Office Action Summary

10/538,542

AEBI ET AL

DETAILED ACTION

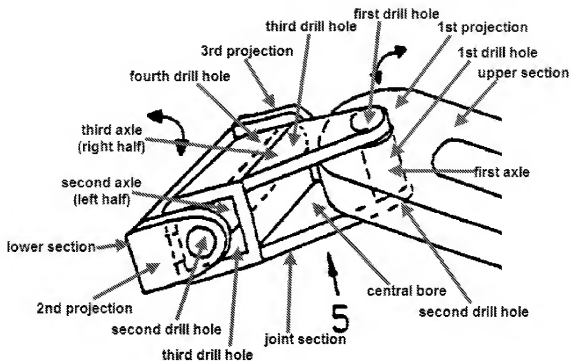
Stranders discloses a universal joint (see examiner-annotated FIG. 2 above) wherein the upper section having a first projection extending from the bottom surface, the first projection including a first drill hole; the lower section having second and third projections extending from the top surface, the second and third projections including second and third drill holes, respectively; and a frame shaped, central joint section located between the upper and lower sections so that the upper section is moveable with respect to the lower section, the central joint section including a central bore and first, second, third and fourth drill holes, the first projection extending from the bottom surface of the upper section being receivable within the central bore formed in the central joint section, the central joint section being receivable between the second and third projections extending from the top surface of the lower section so that a first axle is receivable in the first and second drill holes formed in the central joint section and the first drill hole formed in the first projection, a second axle is receivable in the third drill hole formed in the central joint section and the second drill hole formed in the second projection and a third axle is receivable in the fourth drill hole formed in the central joint section and the third drill hole formed in the third projection.
